Clarksburg Town Center: Site Plan Amendment No. 82007022F

Recommendation – Approval with conditions

Summary

Figure 3 – Previously approved layout

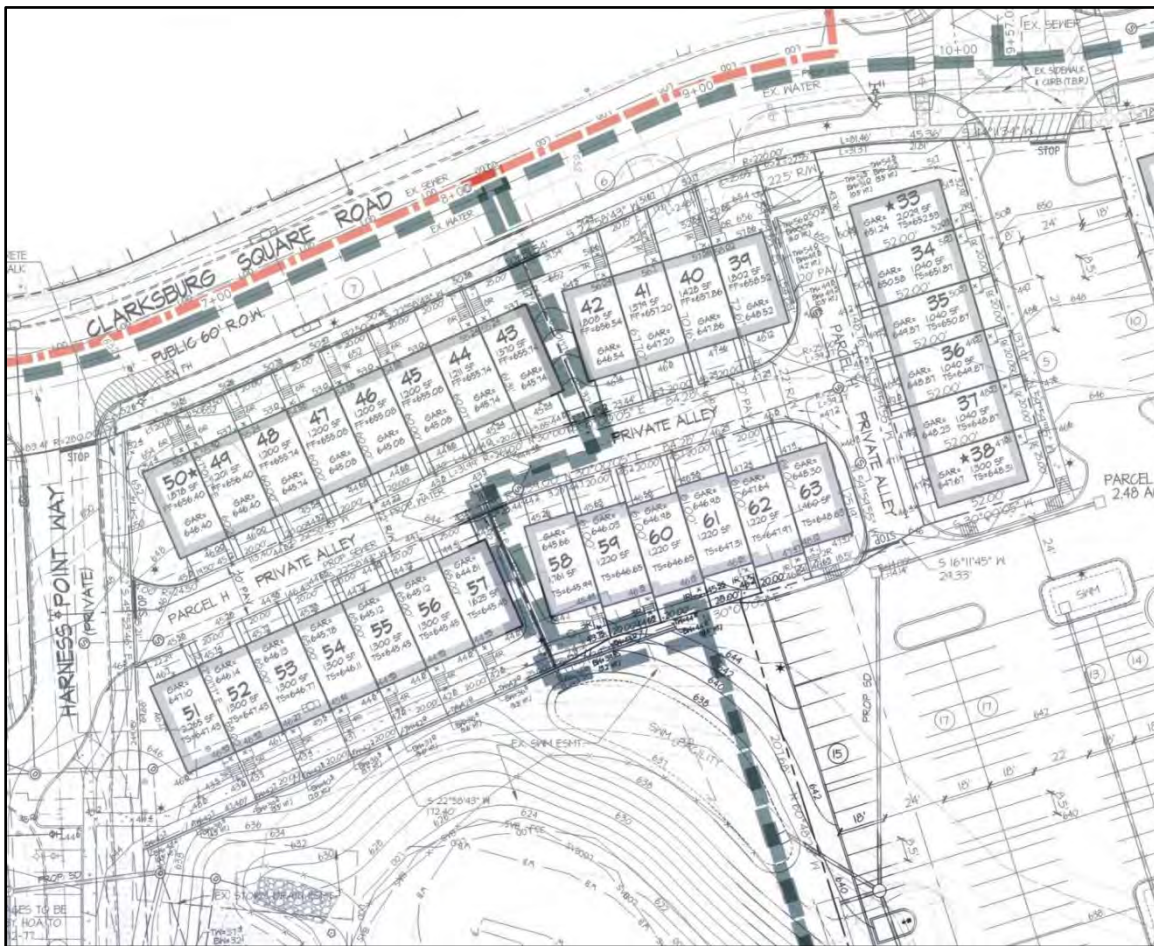
1. Replace the 36-foot deep townhouse units with 40-foot deep townhouse units including minor adjustments to lot lines.
2. Modifications and adjustments to site elements, including lead walkways, retaining walls, sidewalks, and landscaping.

The change from the previously approved 36'-0" deep townhouses to 40'-0" deep townhouses entails minor lot line adjustments for Lots 33-50 and Lots 58-63, within Block GG, and adjustments to site elements to Lots 51-57, within Block GG, to accommodate for the additional 4'-0" of depth to the rear of the townhouses. No additional lots are created under this application. The shifting of the lot lines, within the delineated block boundaries, is minimal and does not drastically alter the overall width or dimensions of the lots, nonetheless the Applicant must record new record plats for the affected lots. Correspondingly, the changes to the unit size result in adjustments to the planting areas and plant material selection. Figures 3, 4, and 5 below highlight the major changes on the Site Plan.

The location of all proposed buildings remains adequate, safe, and efficient. Each of the townhouse buildings will increase by an additional 4'-0" of depth, from the previously approved 36-foot deep units to 40-foot deep units. Lots 33-50 and Lots 58-63, within Block GG, will include minor lot line adjustments and Lots 51-57, within Block GG, will include adjustments to minor site elements. The increase to the building footprint requires minor modifications to grading, specifically to the southeast of Lots 51-57 and Lots 58-63, which pushes the sidewalk and retaining wall to the southeast by about three feet. The horizontal length of the retaining wall will remain the same. While the height will increase by a maximum of 2'-0", the overall height will be no greater than 6'-0". The walkways to the front of each townhouse will be reconfigured to connect to the sidewalks. These changes do not impact the overall quality of the project or the intent of the original approval.
